March 15, 2023

Re.: North Fork Stillaguamish Landscape Analysis Draft Environmental Assessment

Figure 1. Old growth suitability map, proposed treatment areas and spotted owl circles from the Appendix of Wildlife Figures. Includes color-coded “circles of commercial harvest concern.”

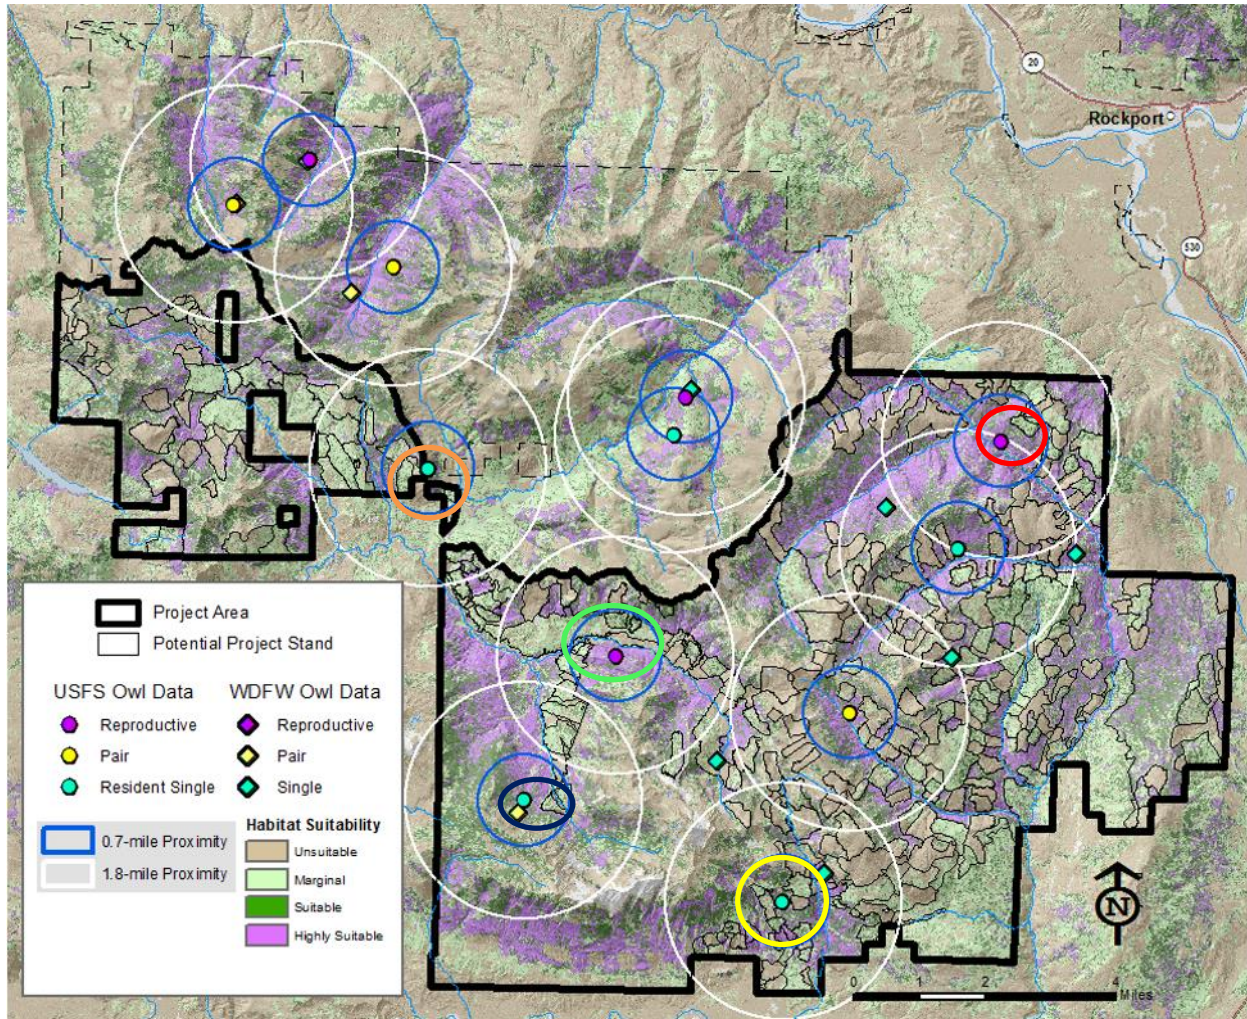
With this in mind, we have some concerns about the potential loss of primary constituent elements in critical habitat, and edge effects to suitable nesting habitat in adjacent critical habitat forest stands (draft EA p. 74-75). We call out in a few specific commercial harvest units within .7 miles of assumed owl presence that will need careful attention - detailed below and in Figure 1 of these comments.

- “NF Stilly” Reproductive (red circle): h16 (33 acres)
- “Round” Single (yellow circle): south half of s12b (83 acres); s13 (9 acres); s14 (67 acres); s38b (11 acres); s15 (31 acres); s37 (20 acres); s36 (16 acres); s20 (17 acres); s21 (20 acres); s19 (26 acres)
- “Deer” Reproductive (green circle): d91 (46 acres); d93 (17 acres); portion of d67 within .7 miles of owl; d68 (5 acres); d70 (3 acres)
- “Higgins Mt” Pair and/or Single (dark blue circle): d89 (75 acres)
- “Finney West” Single (orange circle): d47 (64 acres); d49 (29 acres)
